SUBJECT: RESPONSE TO THE NRC'S REQUEST FOR INFORMATION AND REV. 3 OF OUR
QUALITY ASSURANCE PLAN

REQUEST FOR ADDITIONAL INFORMATION BASALT WASTE ISOLATION PROJECT QUALITY ASSURANCE PLAN REVISION 1, APRIL 15, 1986

BASALT WASTE ISOLATION PROJECT
 QUALITY ASSURANCE PLAN, REV. 3

FIGURE 1-2

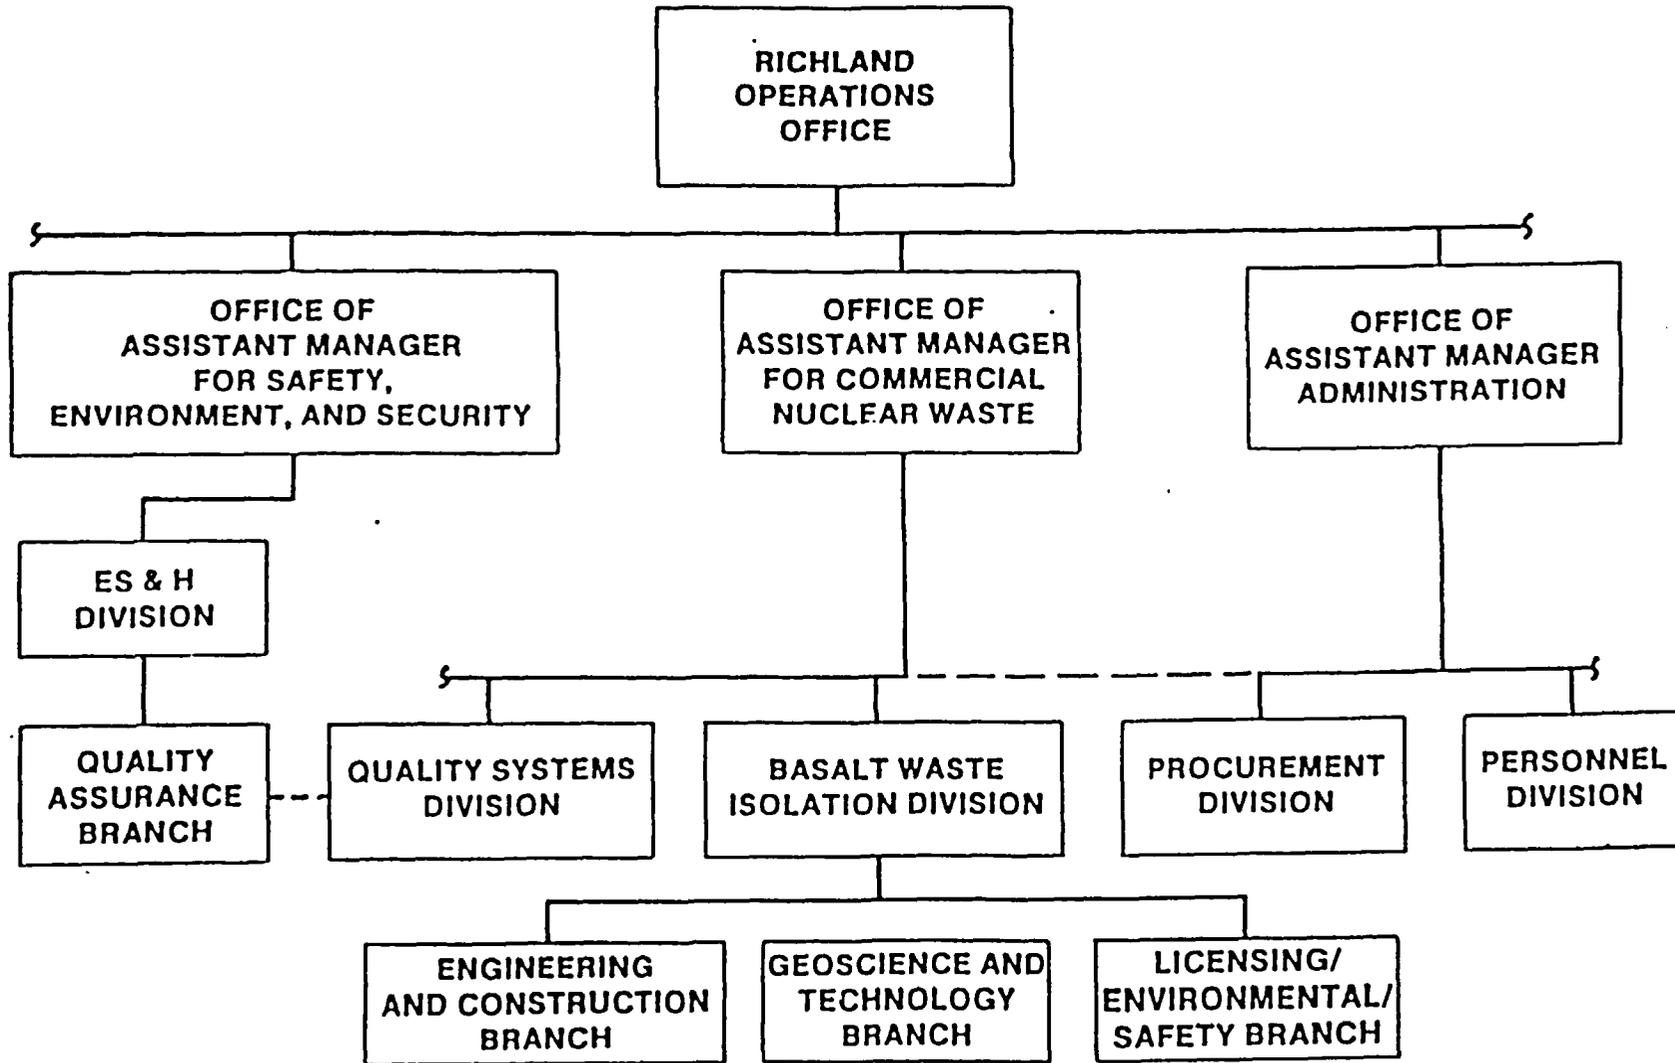
7. Clarify whether the Director, BWI Division, reports through the Office of Commercial Nuclear Waste (Section 1.3.1) or the Office of Civilian Nuclear Waste (Figure 1-2). Identify the onsite and offsite organizational elements which function under QA program controls of justify not doing so. Show the ES&H Division, the Procurement Division, and the Personnel Division on an organization chart. (1.7)

The directors of Basalt Waste Isolation Division and the Quality Systems Division report to the Assistant Manager for Commercial Nuclear Waste (AMC). Figure 1-2 has been modified to reflect all of the DOE-RL divisions that support the project. Section 1.2.4 has been revised to indicate that the Architect/Engineer is the only offsite organization. This was initially corrected in Revision 2 with further modification in Revision 3.

FIGURE 1-3 BWI PROJECT QA PROGRAM MANAGEMENT RESPONSIBILITIES

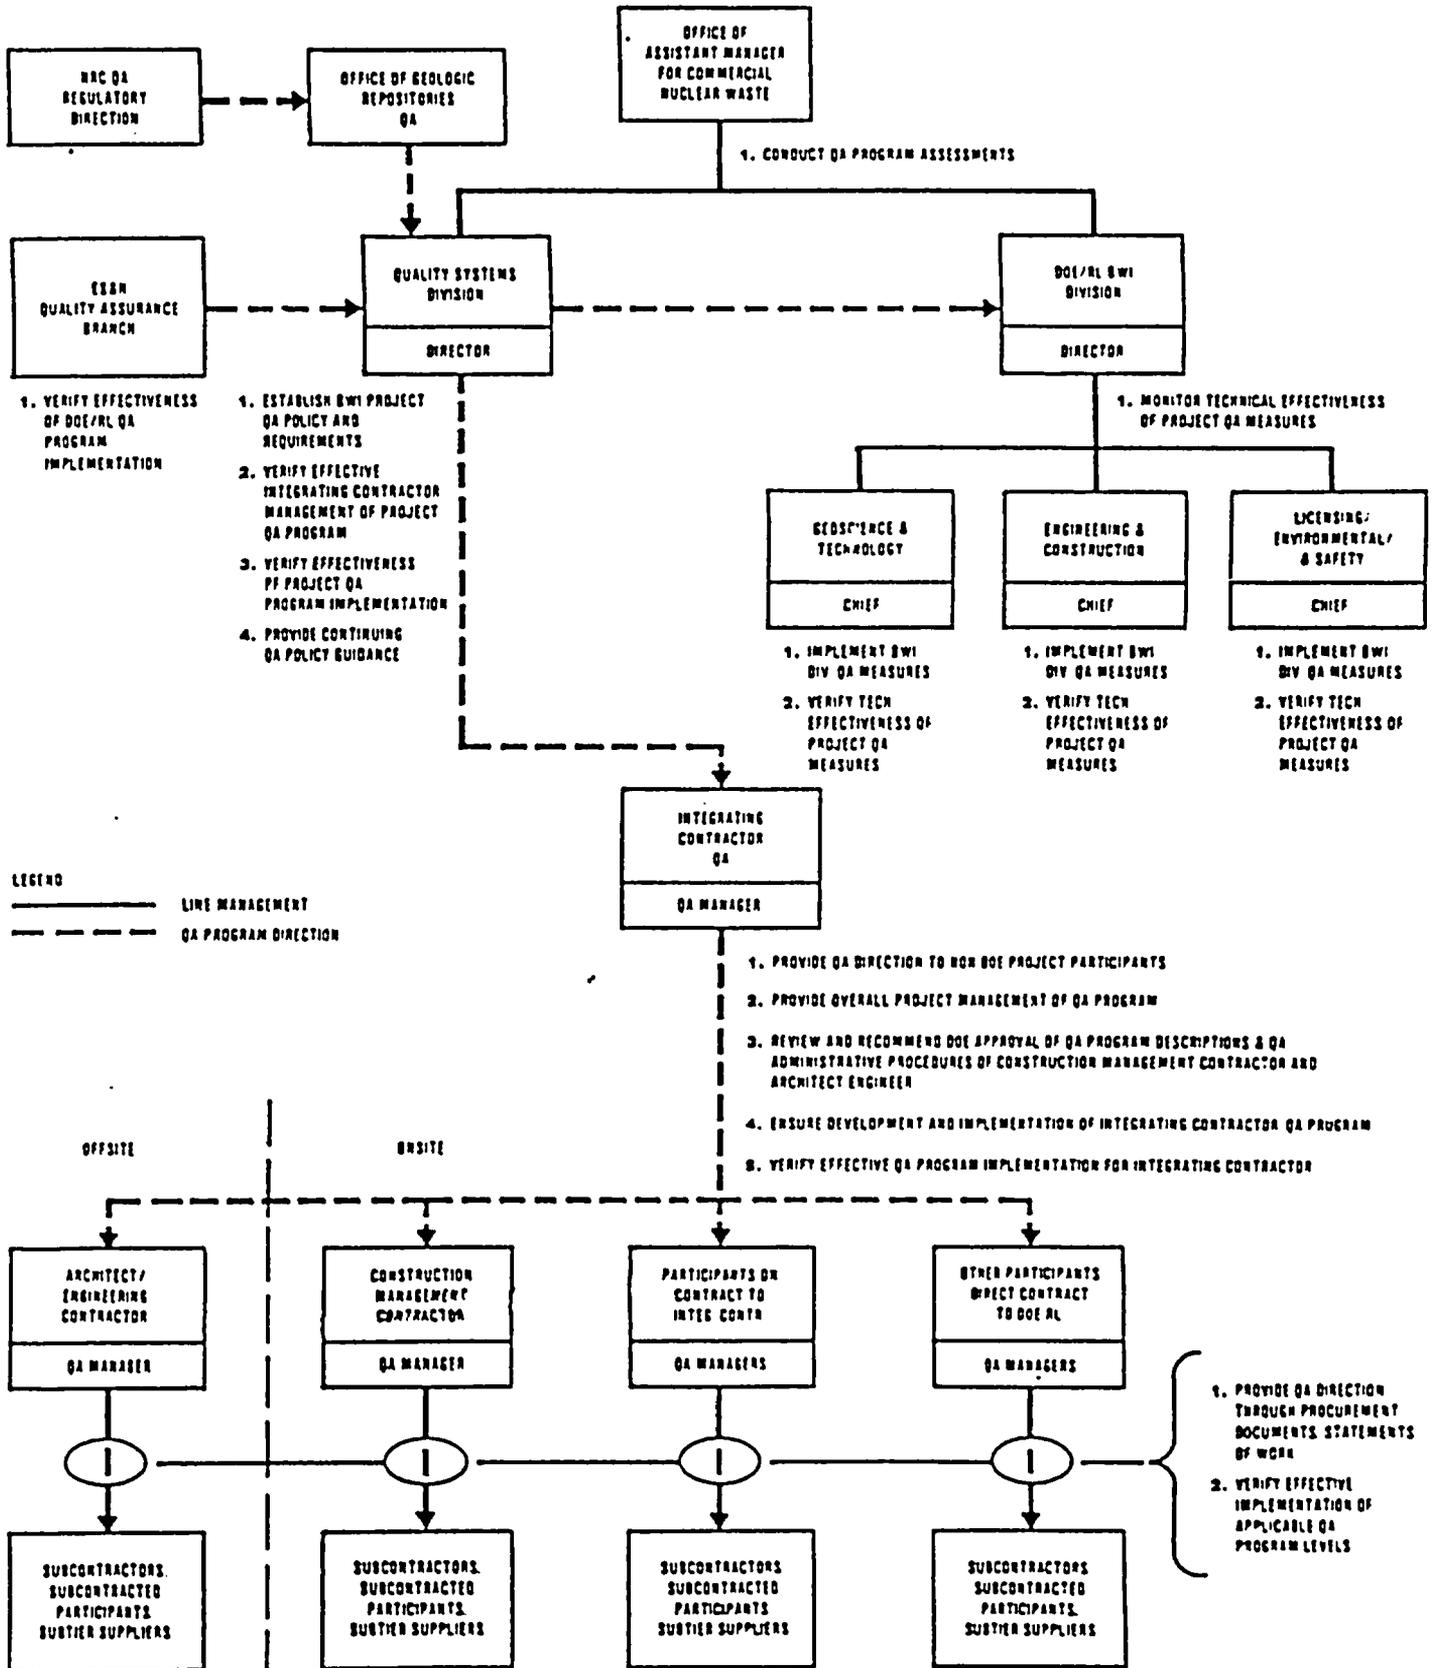
3. Section 1.3 and Appendix A of the plan describe QA responsibilities within the BWI Division. Identify who (by position title) in the Richland Operations Office is responsible for the overall BWI program. Clarify the meaning of the dashed lines, arrowheads, and ellipses on Figure 1.3 of the plan. Also indicate what ES&H stands for on Figure 1.3 and Section 1.5 of the plan. (1.1)*

Section 1.3 has been completely rewritten in Revision 2 to reflect the AMC organization. The Assistant Manager for Commercial Nuclear Waste is the Project Manager and is responsible for the Basalt Waste Isolation Project. Figure 1-3 has been clarified by providing a legend. The ellipses indicate

the listed responsibilities apply to each participants' QA Manager. Figure 1-2 has been revised to show the Environmental Safety Quality Assurance and Health (ES&H) Division and Section 1.5c has been added to describe their functions on the BWIP in Revision 3.
